Revised August 11, 2008

### **Subtask 2.3. Track, Signal and Grade Crossing**

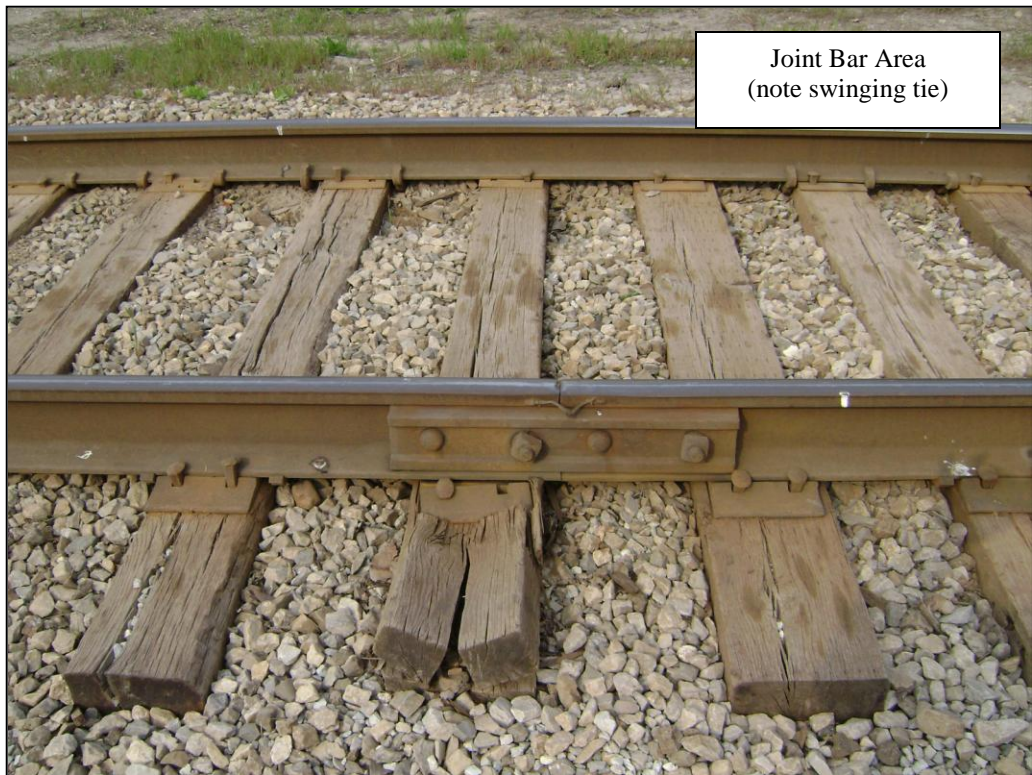
Additionally, a mid-day layover track is proposed to be constructed at the east end of Osmer Siding (see photo at top of next page) consisting of a hand-throw switch (off of the siding) providing access to a single 5,000 foot side track. Standby power would be supplied at this location as well. Access to this layover track would be by gravel road.

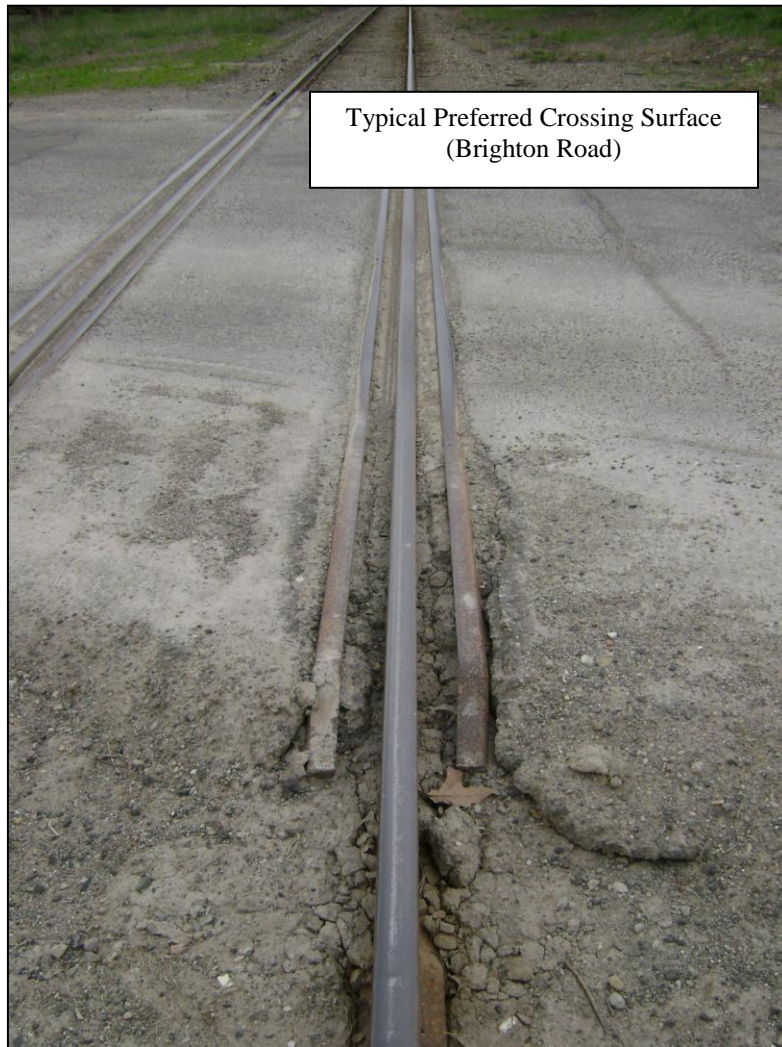
RLBA believes there are sixteen existing main track turnouts, such as the north end of Whitmore Lake Siding (see photo). RLBA estimates about 25 percent of the existing
